Preliminary Drainage Report  
for  
**Rolling Hills Ranch PUD**  
at  
**Meridian Ranch**

February 2020

PCD Project No. PUDSP-19-009

### REGIONAL WATER QUALITY CALCULATION

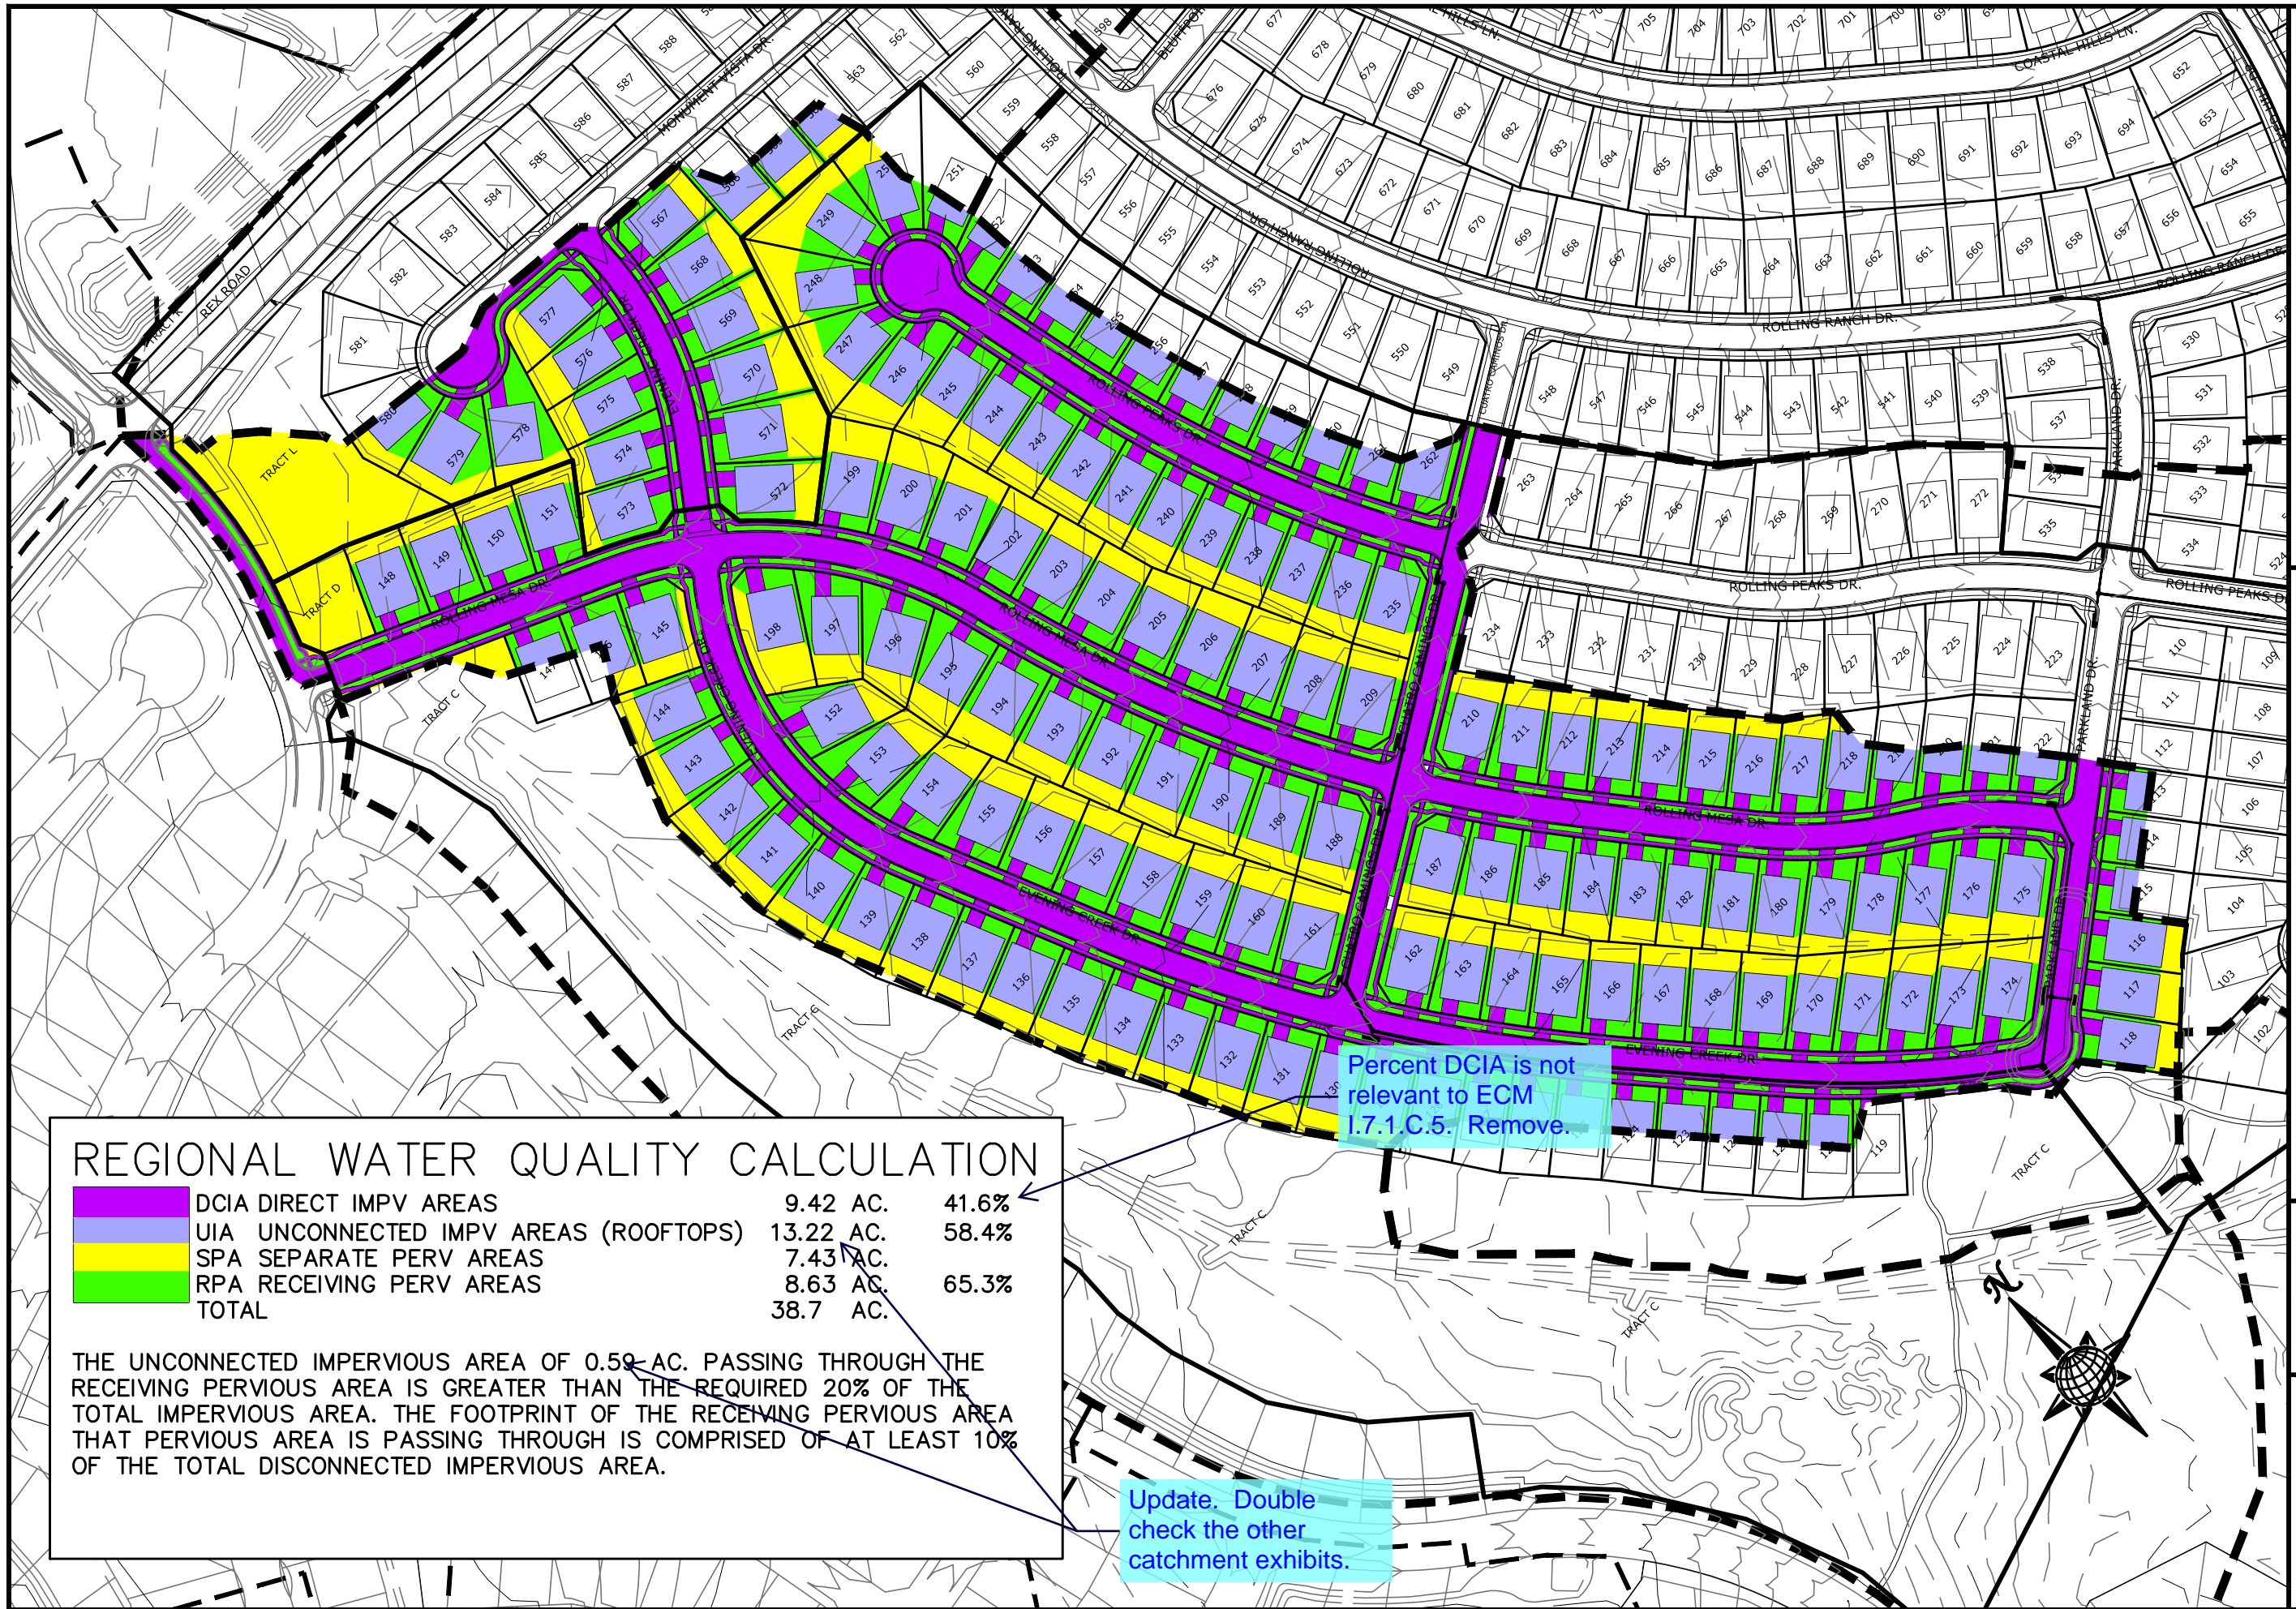
Percent DCIA is not relevant to ECM I.7.1.C.5. Remove.

Scale	NTS.
Drawn by	TAK
Checked by	
Sheet Number	4
Date	FEB 2020

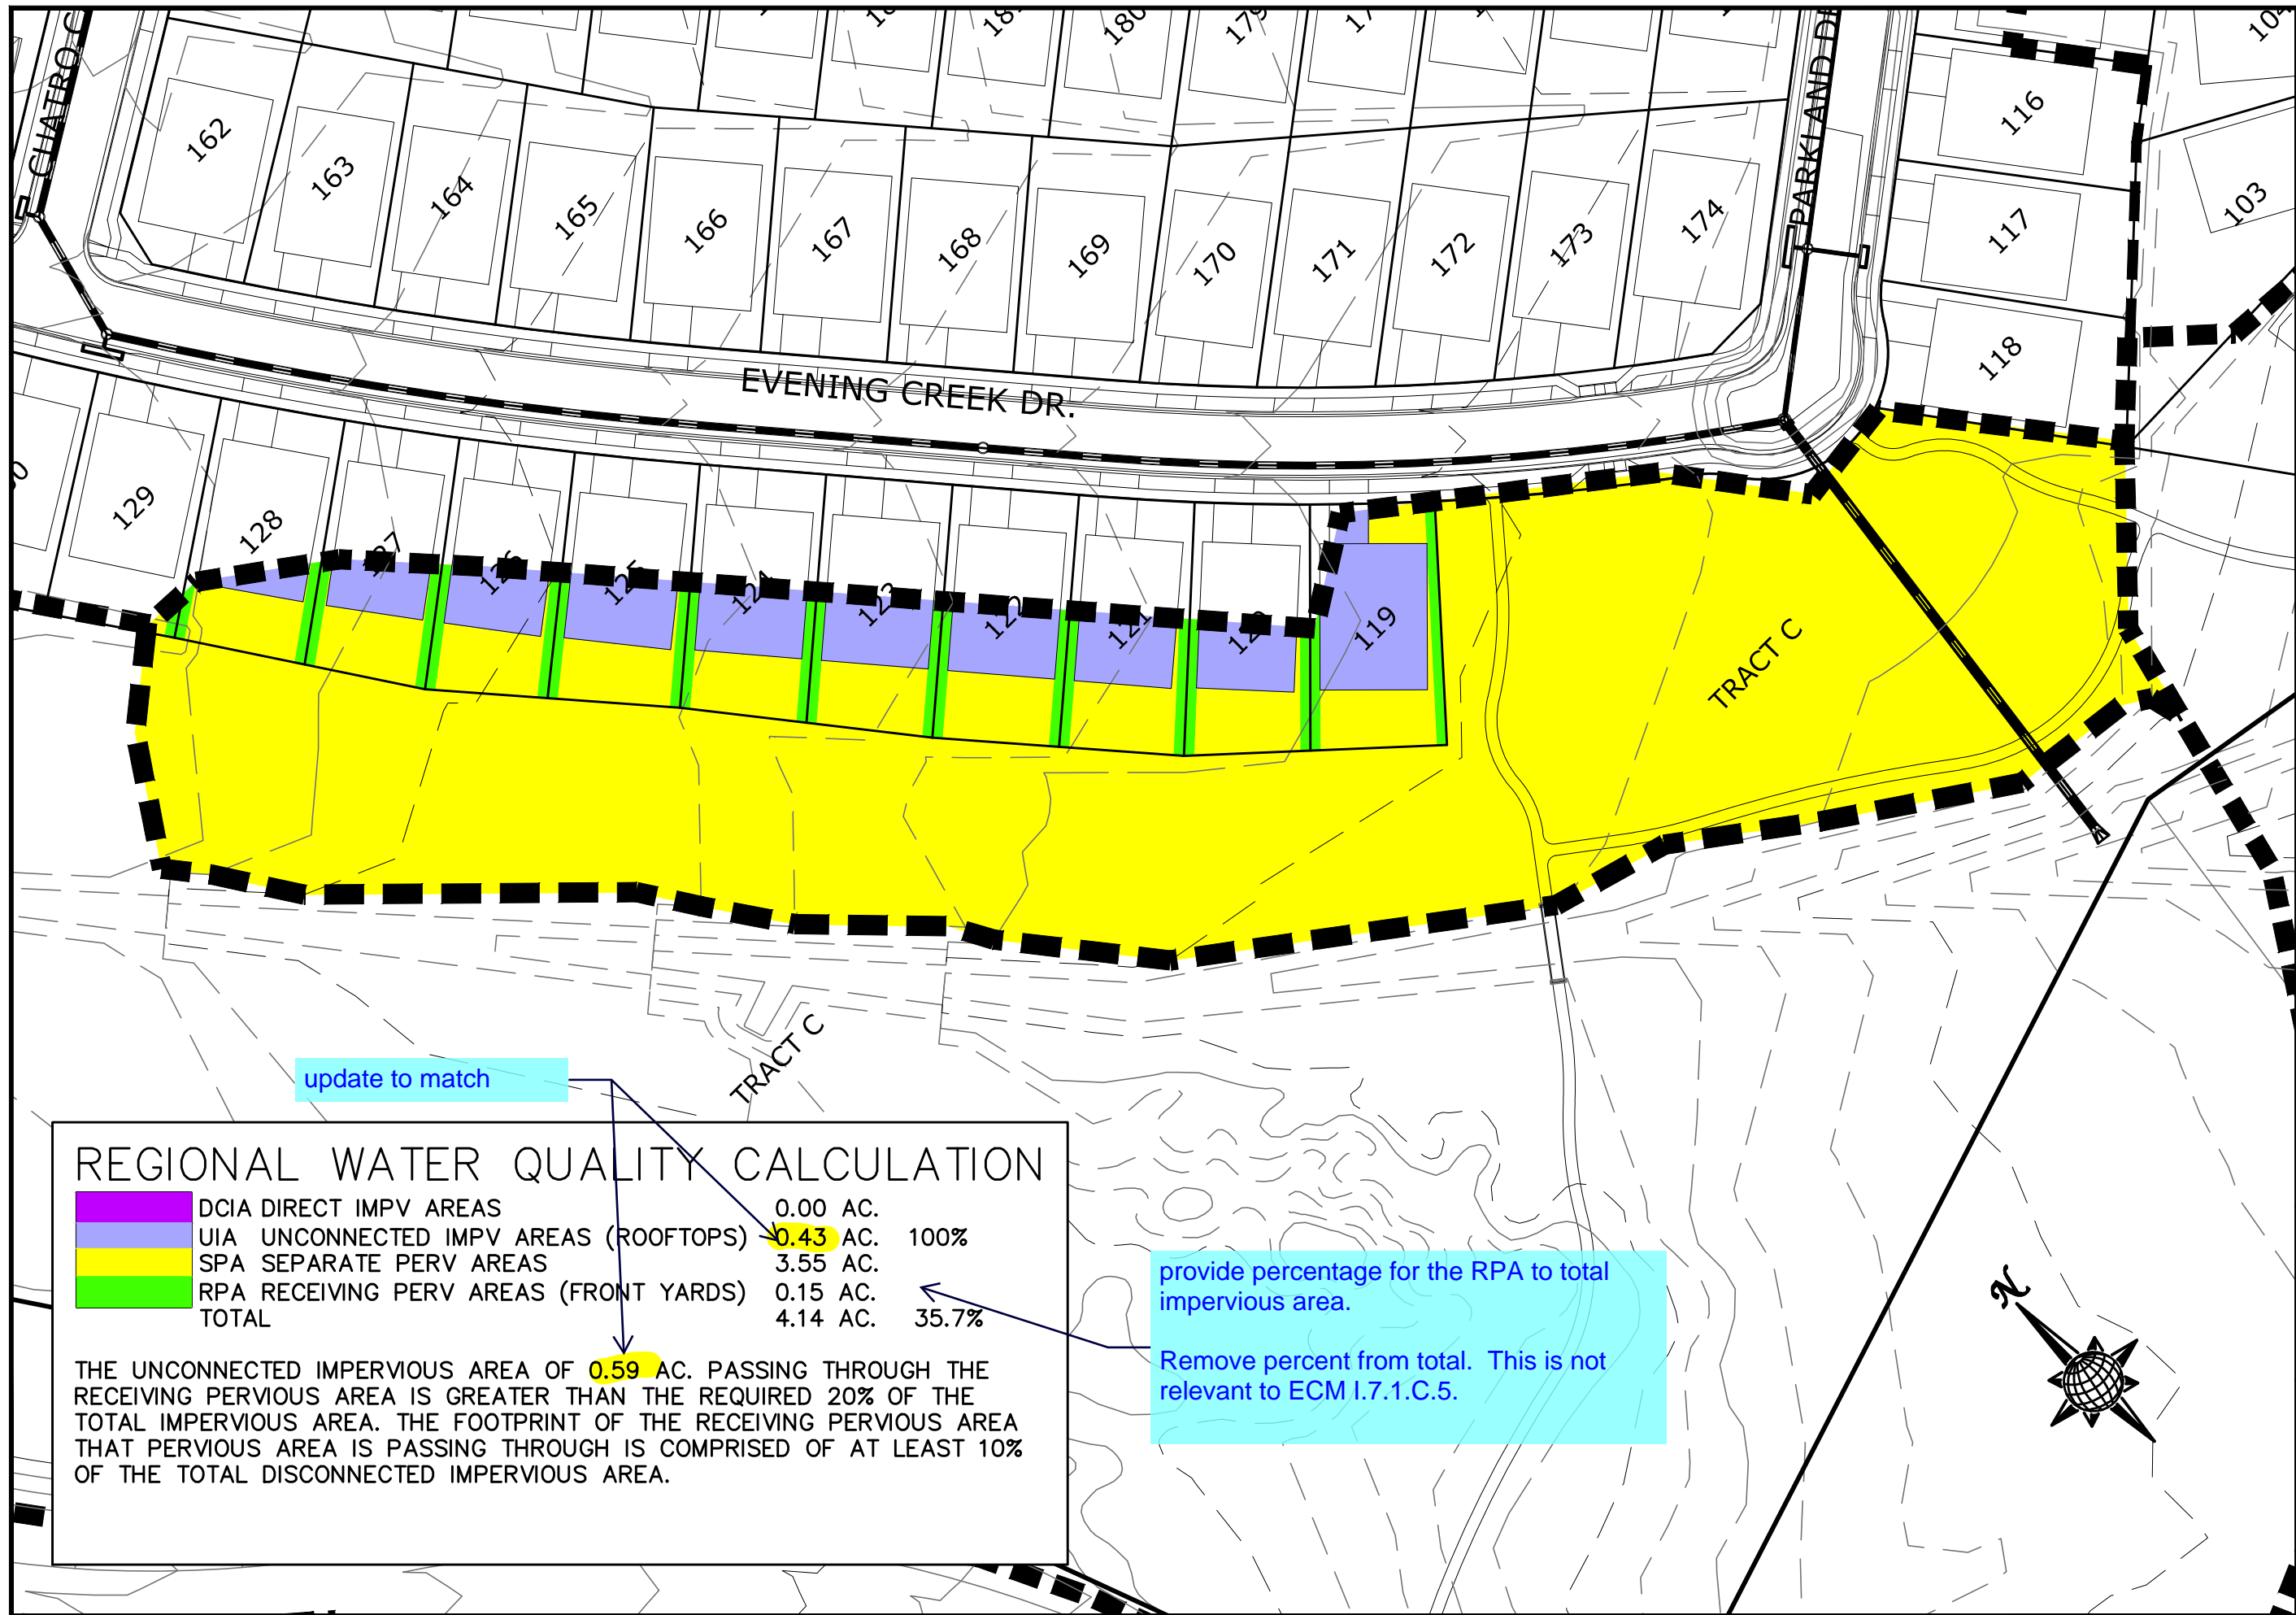
Update. Double check the other catchment exhibits.

**REGIONAL WATER QUALITY**  
 CATCHMENT AREA B2  
 ROLLING HILLS RANCH PUD

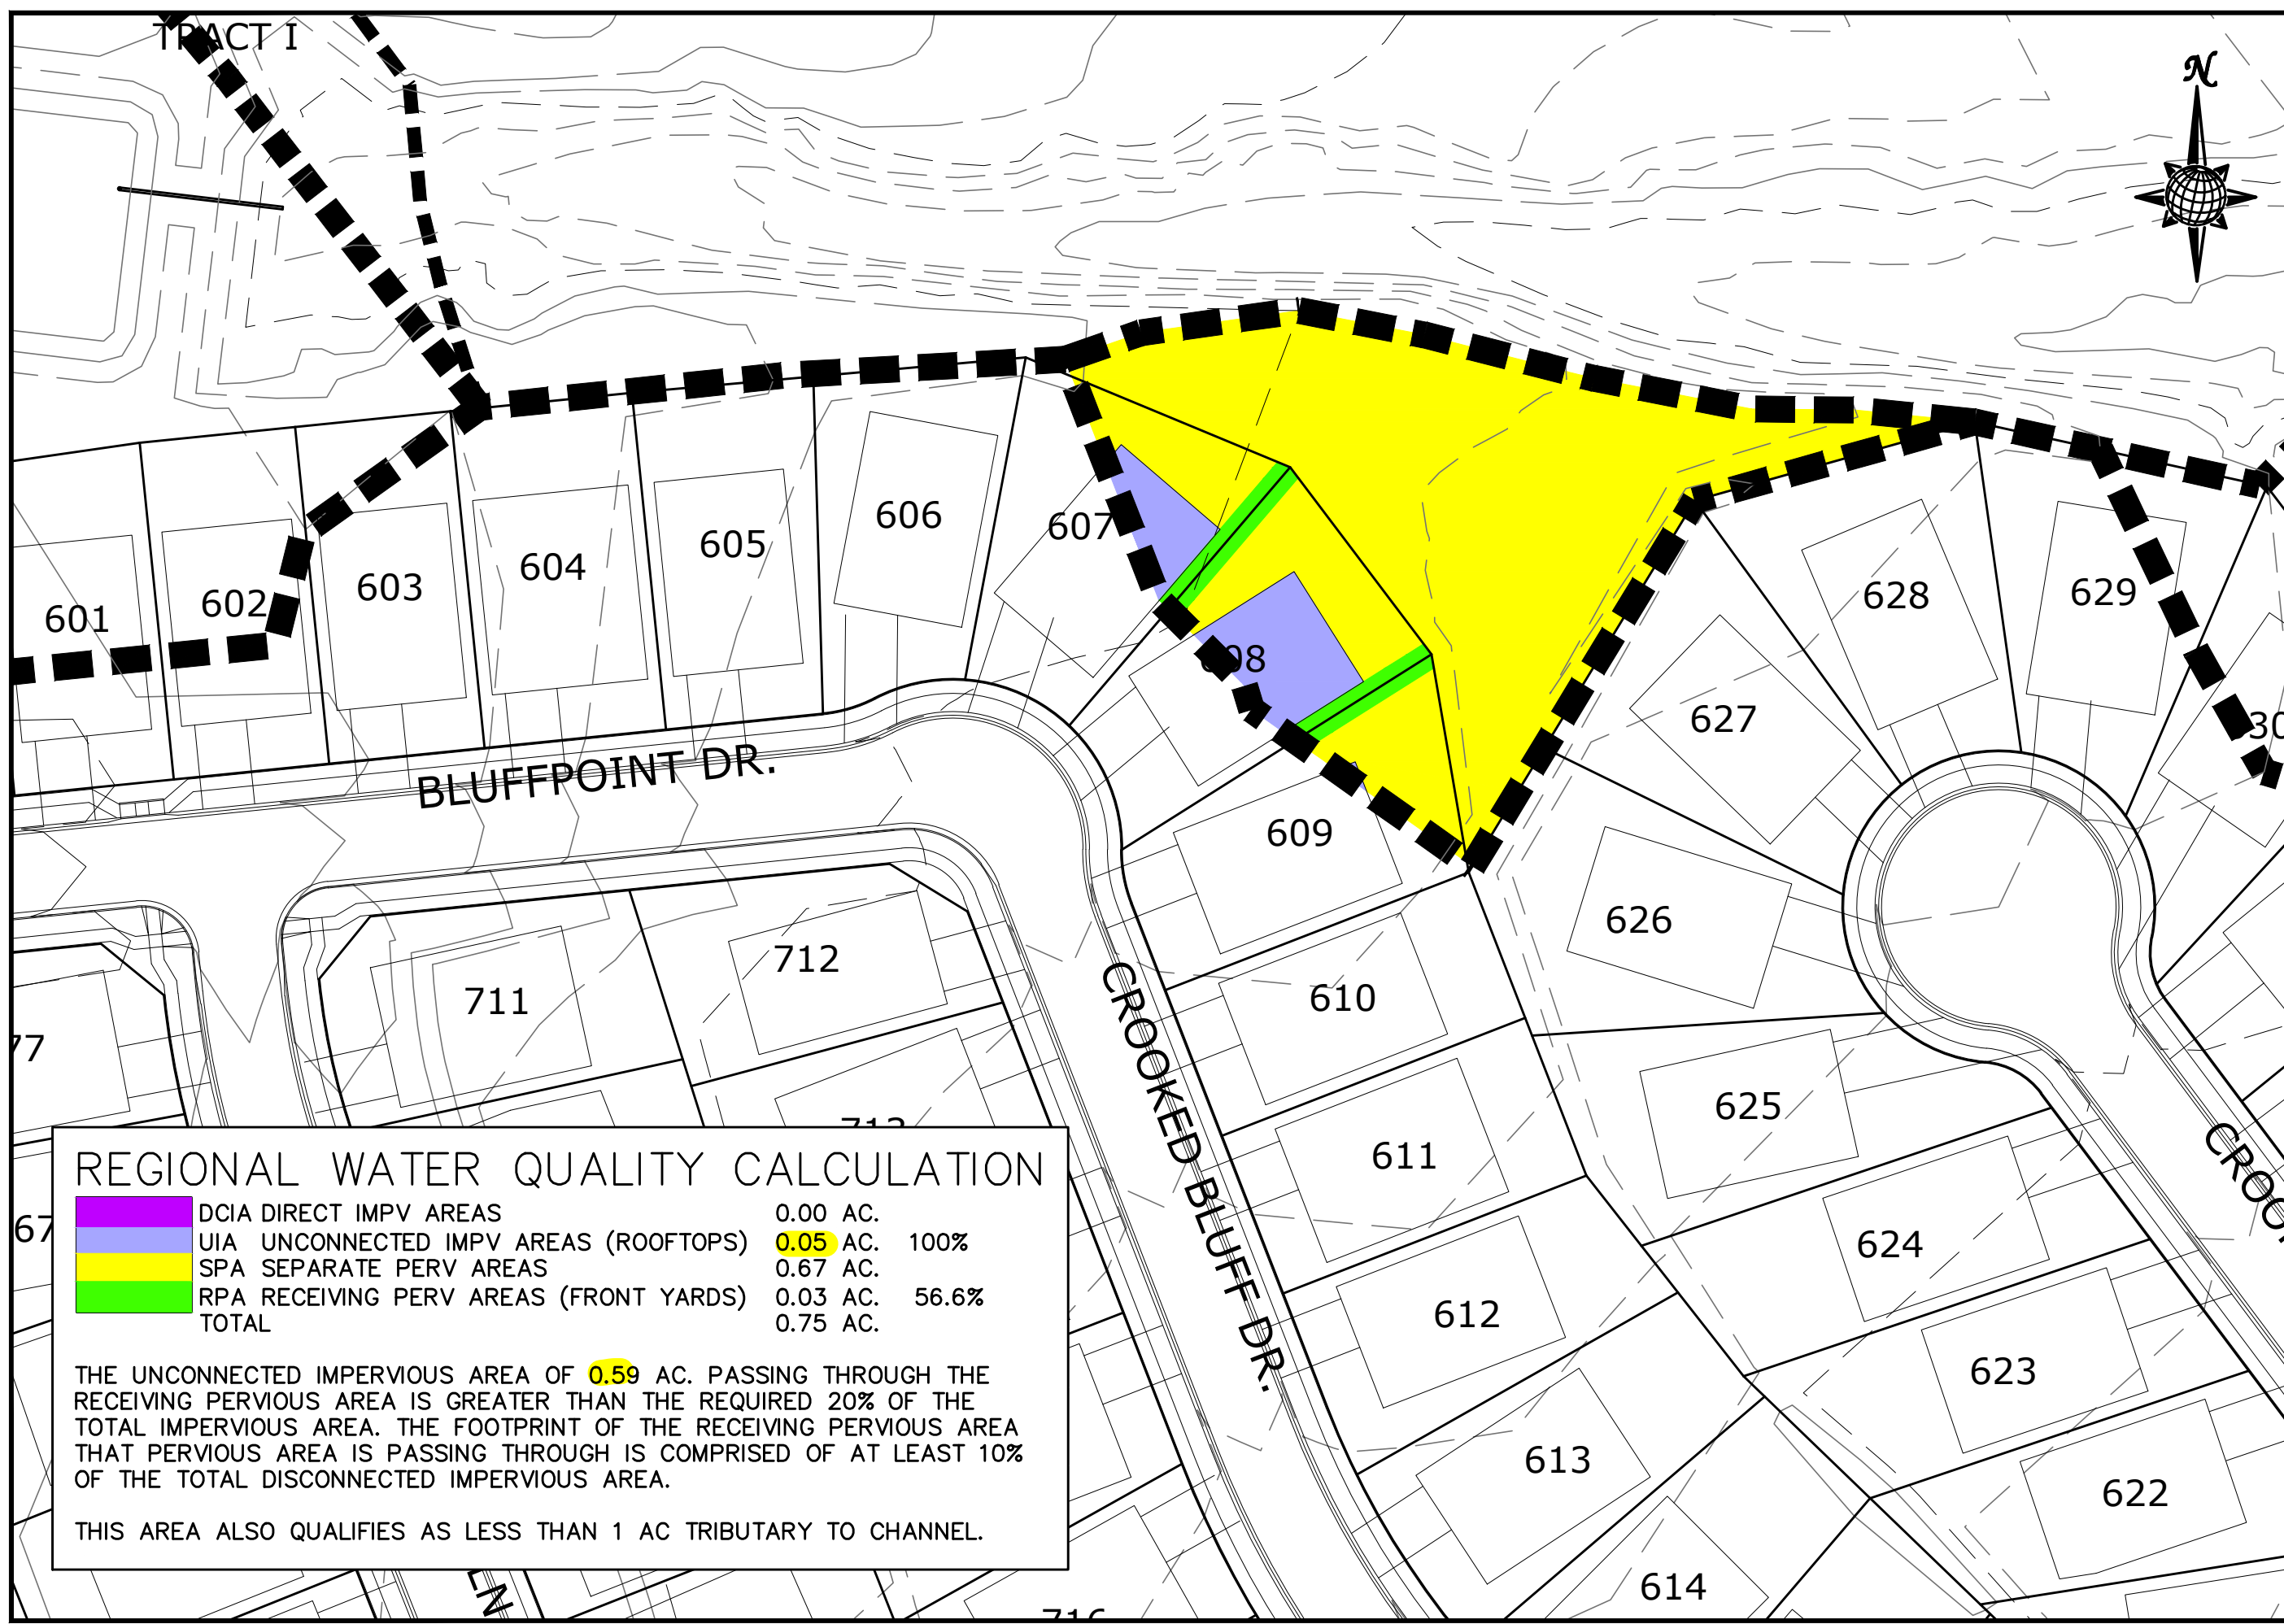
provide percentage for the RPA to total impervious area.

Remove percent from total. This is not relevant to ECM I.7.1.C.5.
